ADDENDUM NO. 1

July 20, 2026

This Addendum is hereby made a part of the Contract Documents and modifies and takes precedence over the original Contract Documents dated July 7, 2026.

LEBANON COUNTY MUNICIPAL BUILDING
PHASE II RENOVATIONS
22-036

1.16 A101 FLOOR PLAN

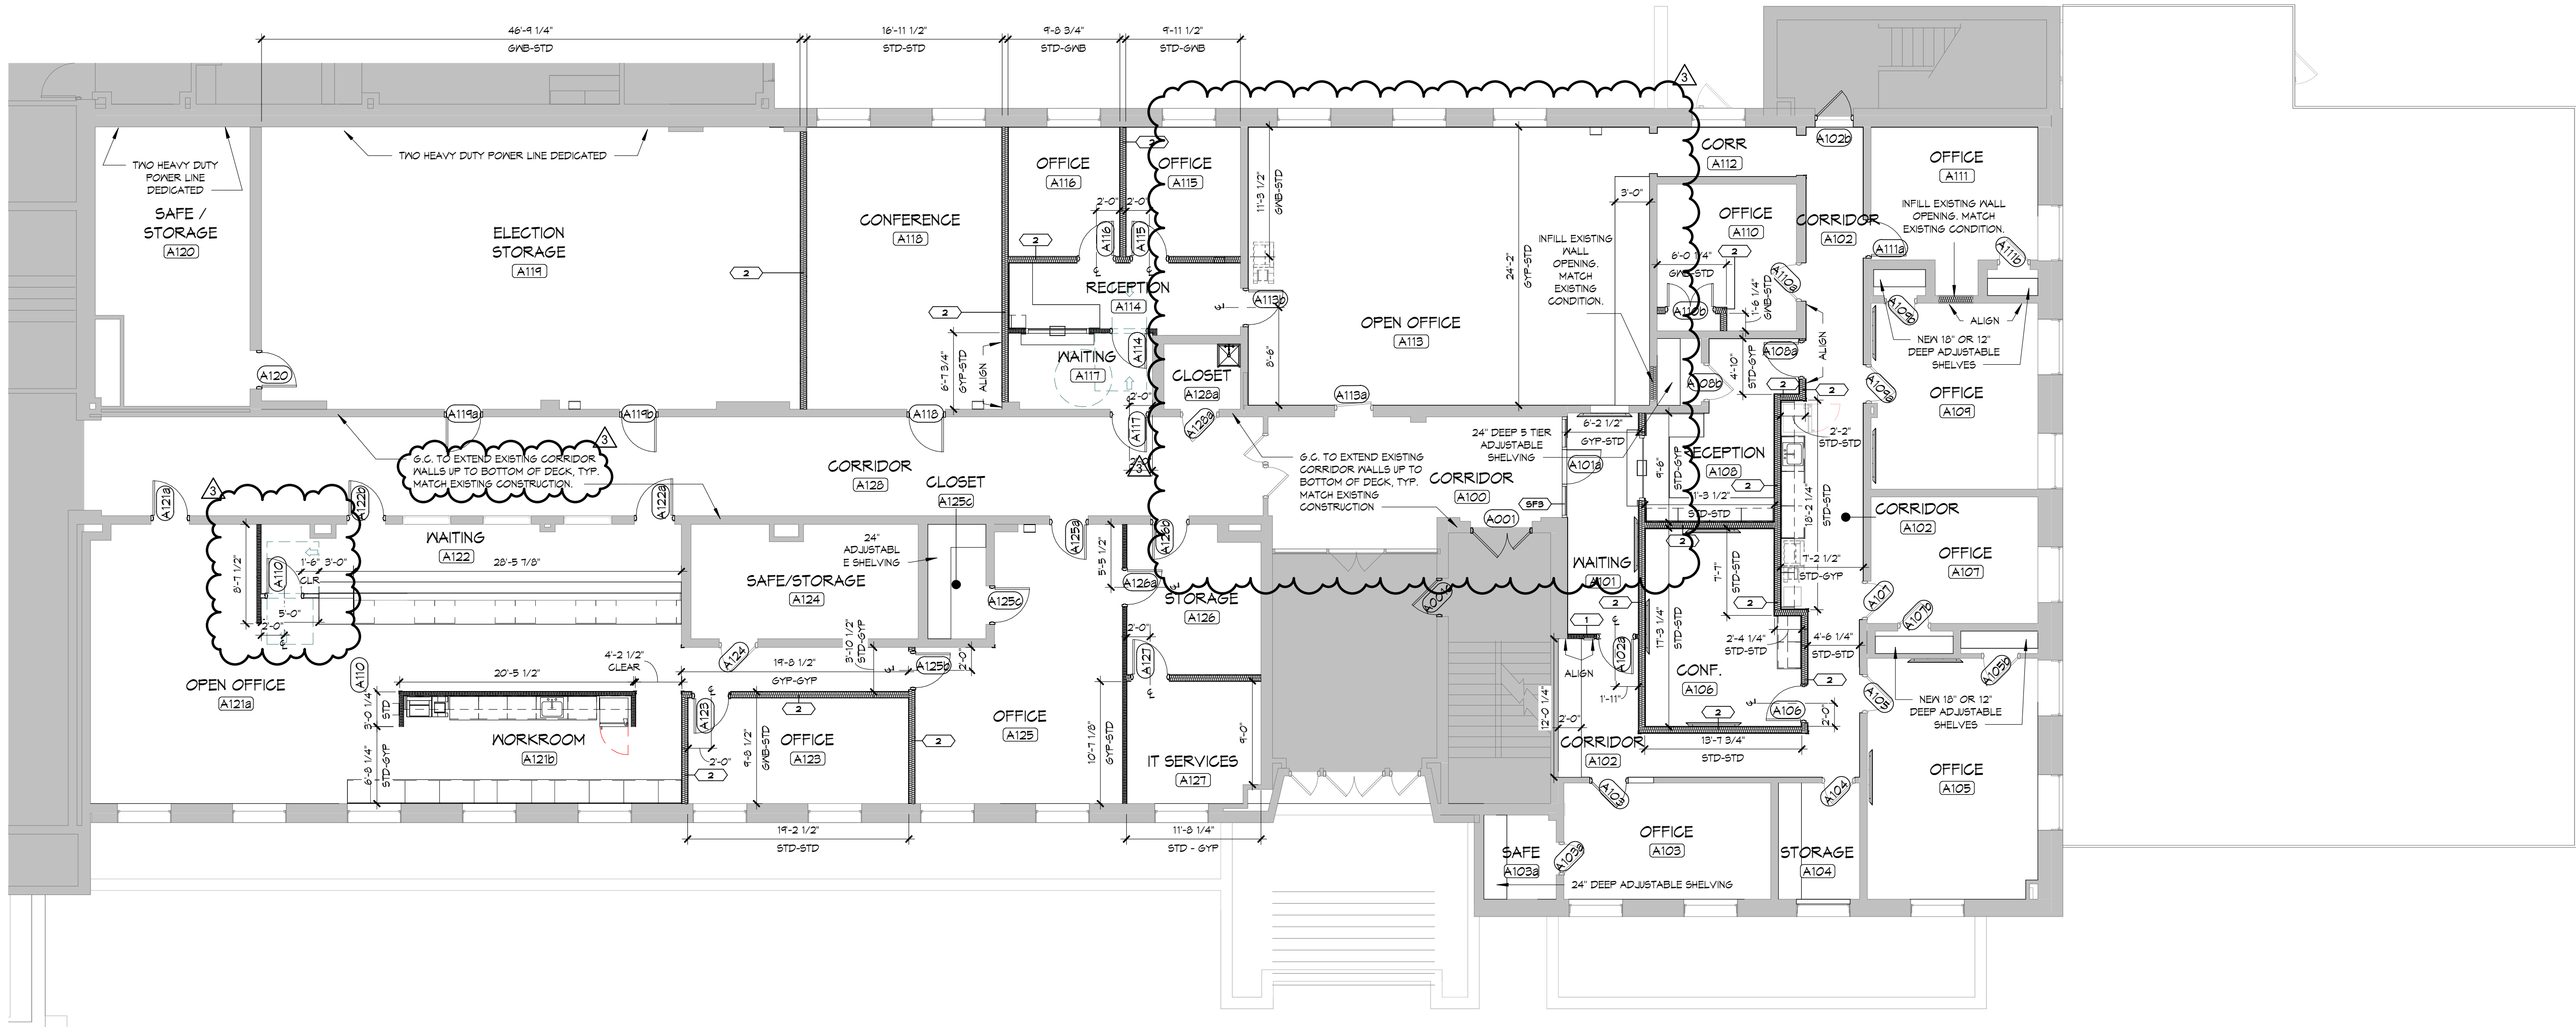
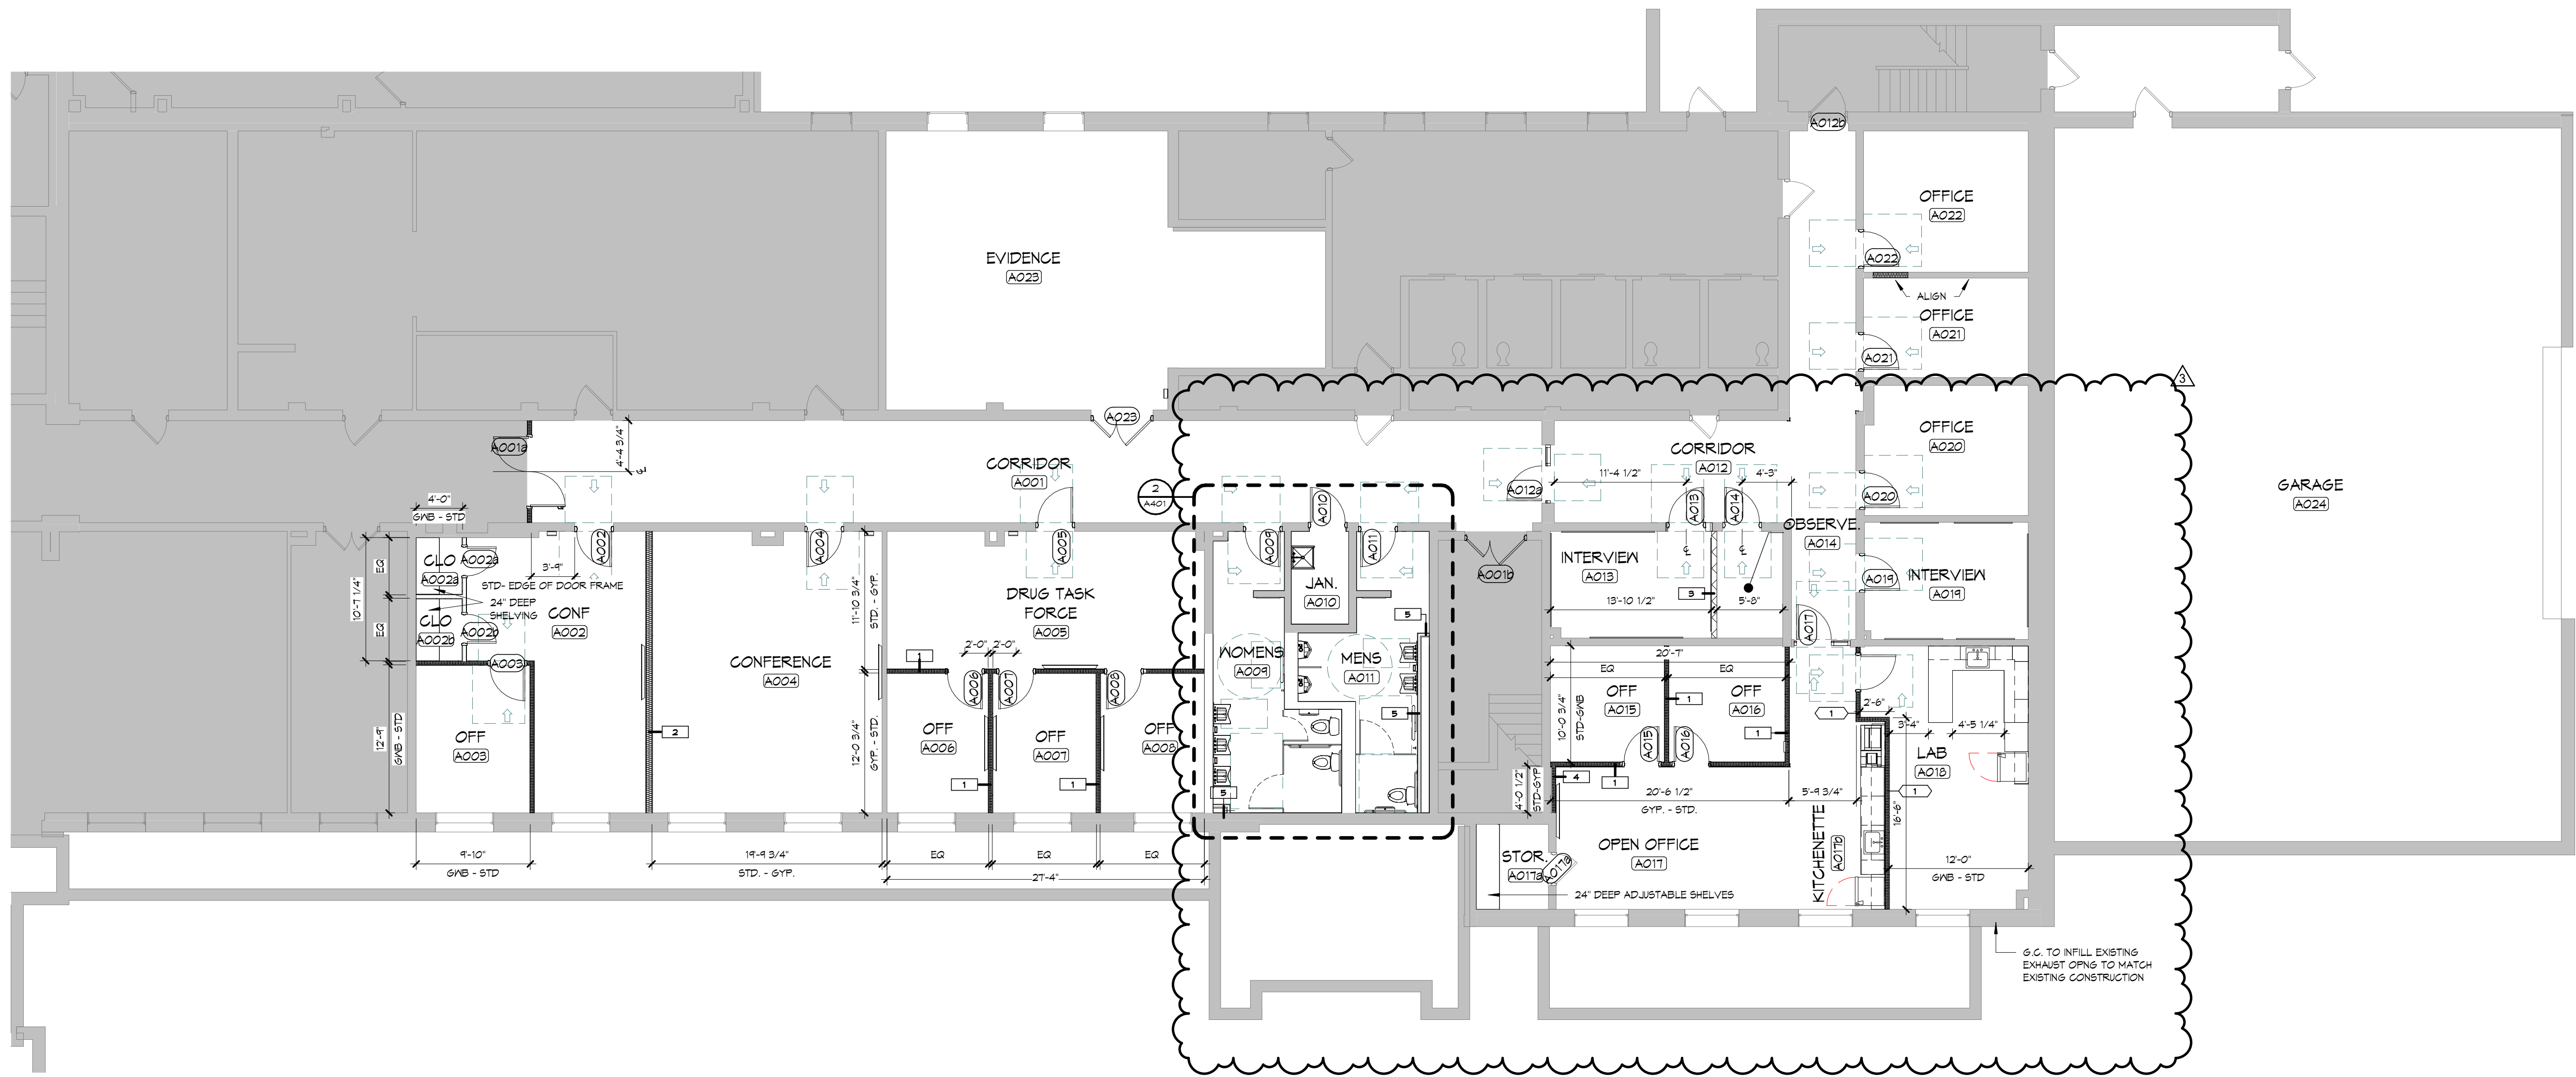
- a. REVISE Ground Floor Plan.
- b. REVISE First Floor Plan.
- c. ADD First Floor Plan Notes.

1.17 A111 REFLECTED CEILING PLAN

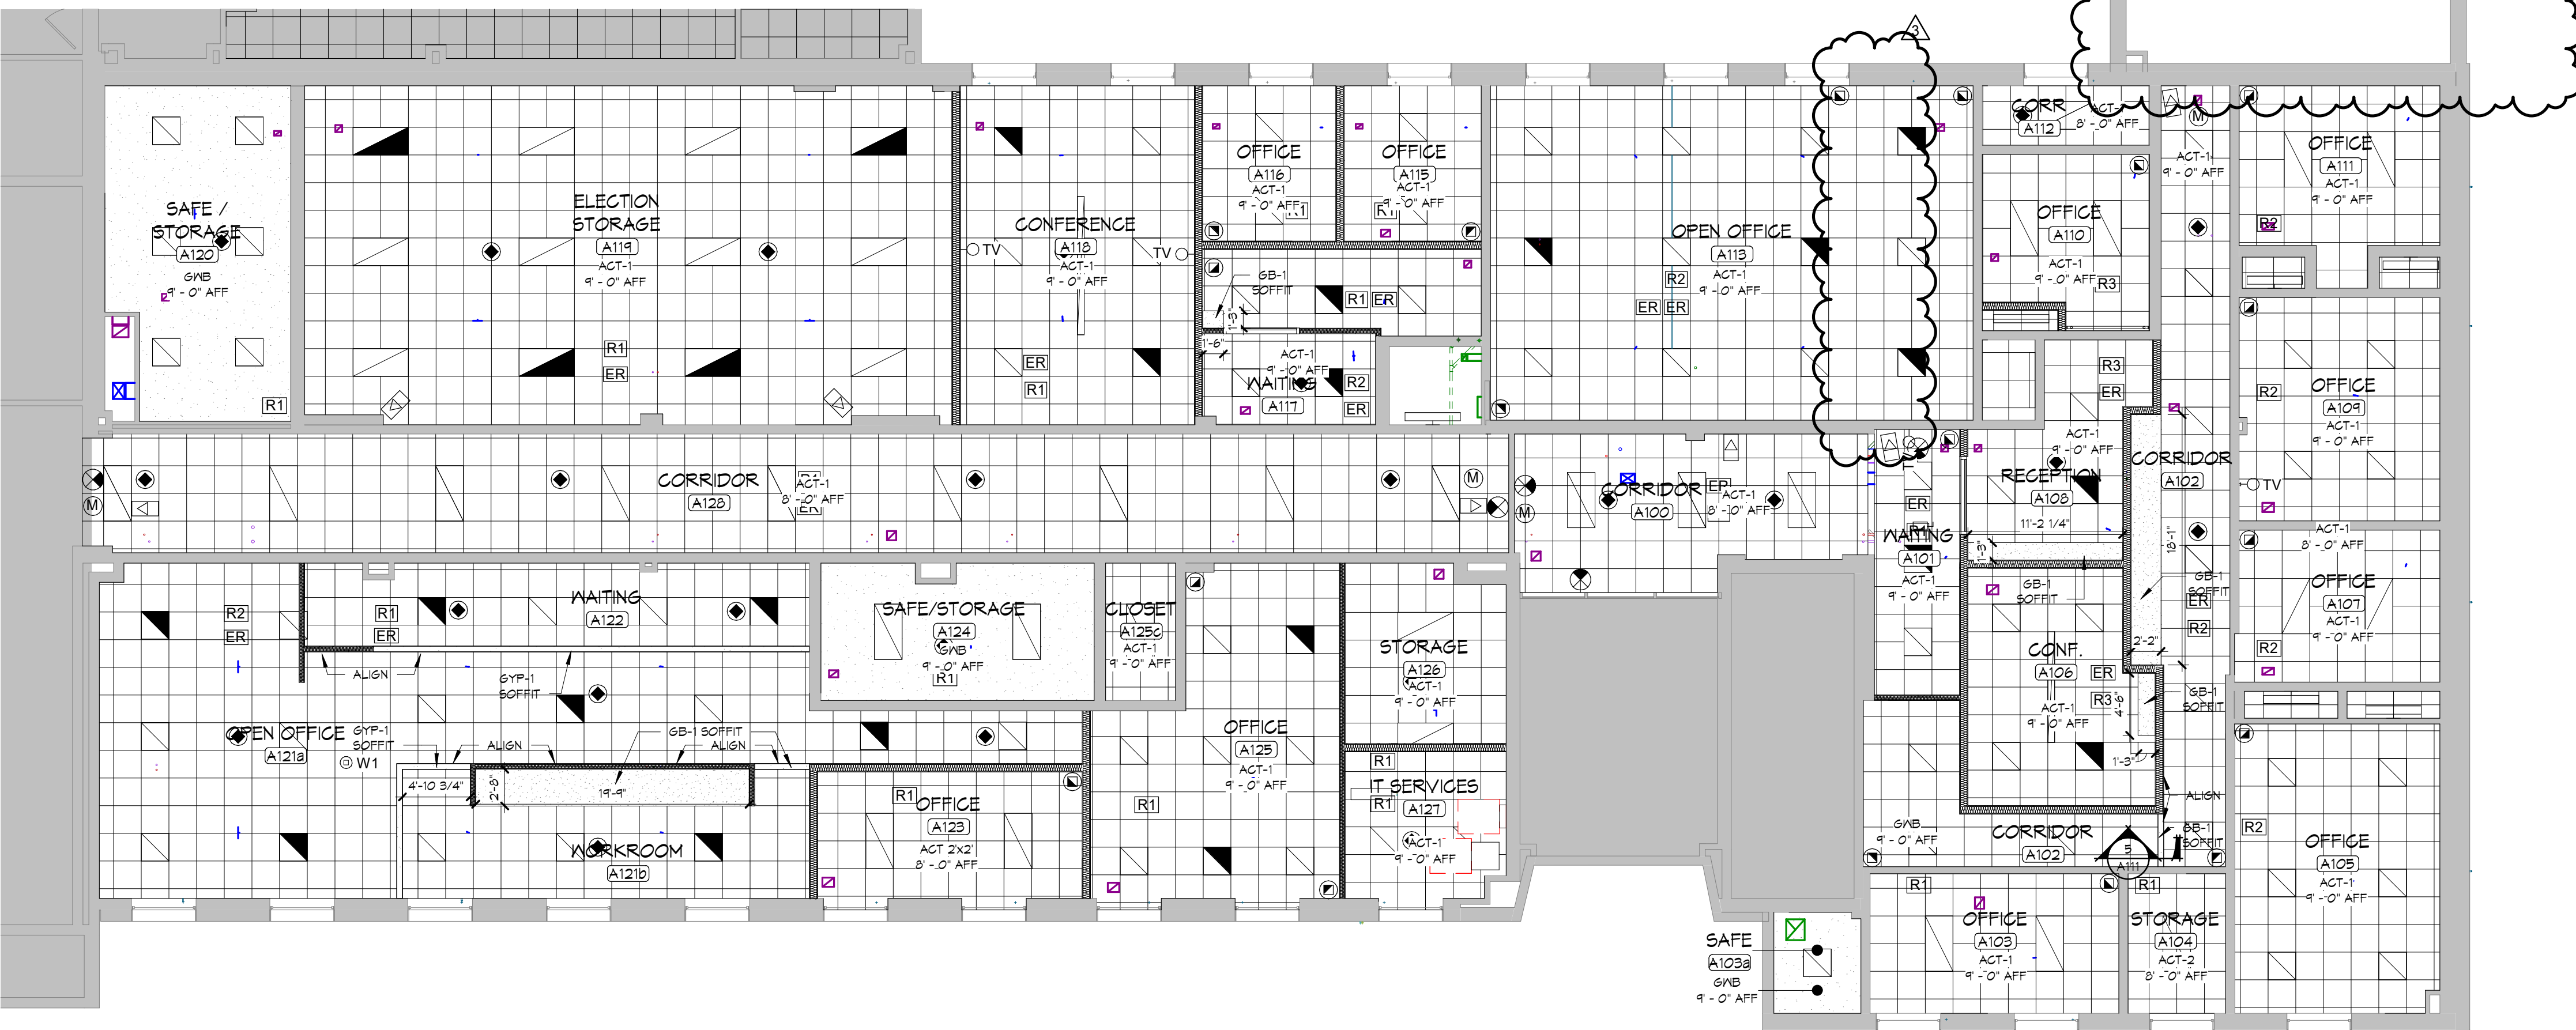
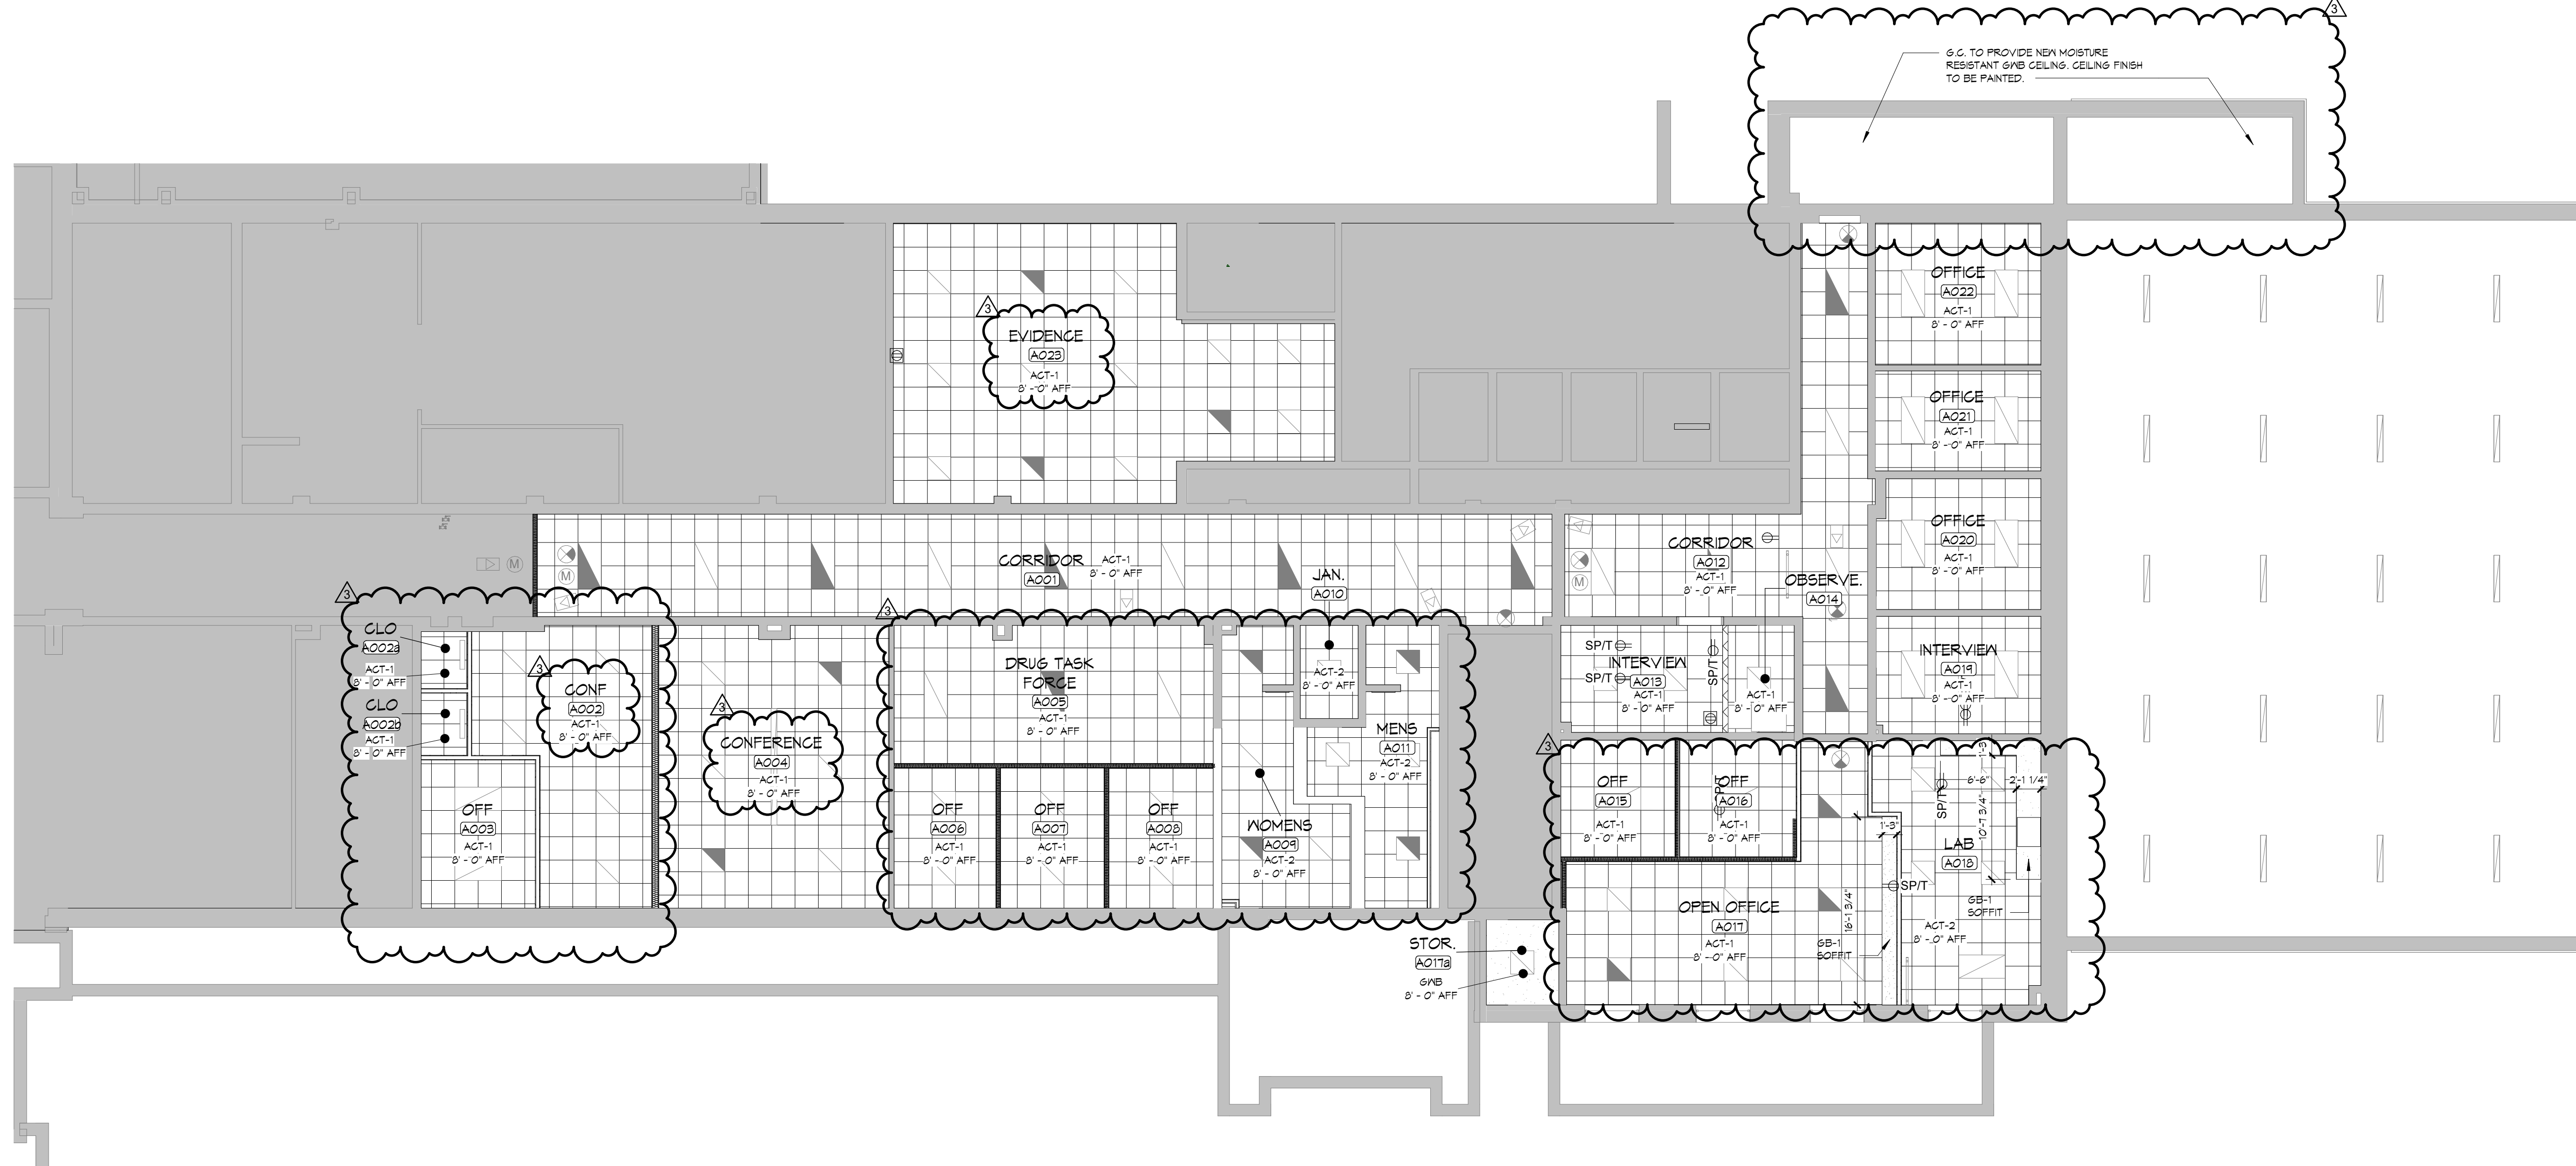
- a. ADD Stair Tower Scope.
- b. REVISE Ground Floor RCP.
- c. REVISE First Floor RCP.
- d. REVISE Ceiling Legend Note.
